**Re: Addendum #2 for ITB 21368 – MetroHealth Clinic Upgrades at Clara Westropp, Mound, and Glenville**

This Addendum #1 reflects the following:

**Re:** PRE-BID QUESTION AND SITE VISIT RESPONSES: MetroHealth New Health Care  
Expansion Program

**D1 LOCKER BASE DEMO**  
SCALE: 1/2" = 1'-0"

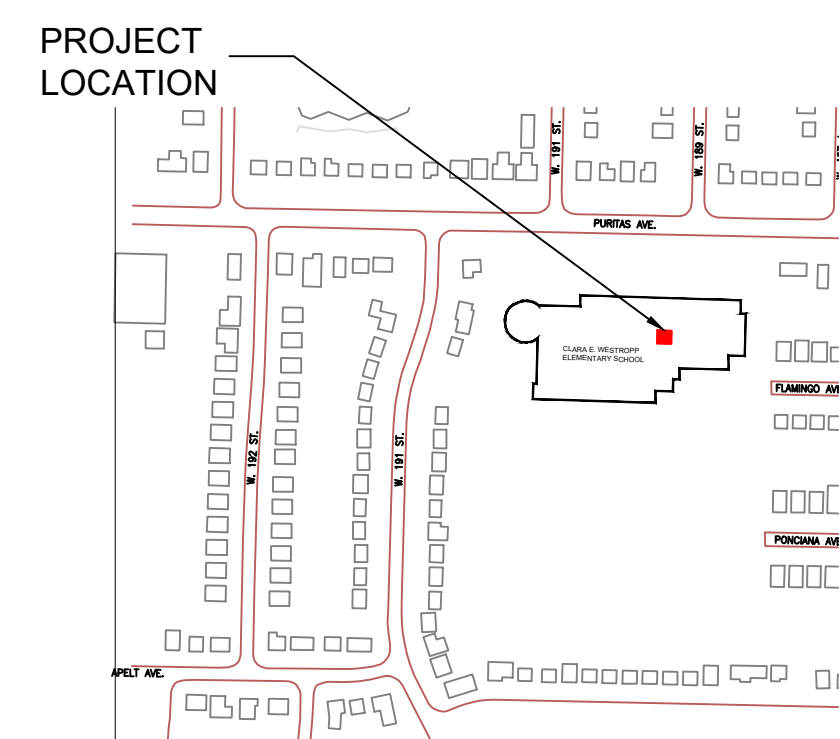
- 1.0 Also, ACM material appears to remain at perimeter of rooms potentially requiring existing concrete to be ground in prep for new finishes.
- 2.0 All ceilings are to be new ACT and grid.
- 3.0 Entire locker base to be removed and floor leveled with existing in preparation for new flooring. See Detail D1 on Sheet A1.0.

REMOVE EXIST. LOCKER BASE. PROVIDE NEW ARDEX OR APPROVED EQUAL FLR. LEVELING IN PREP. FOR NEW FLOORING
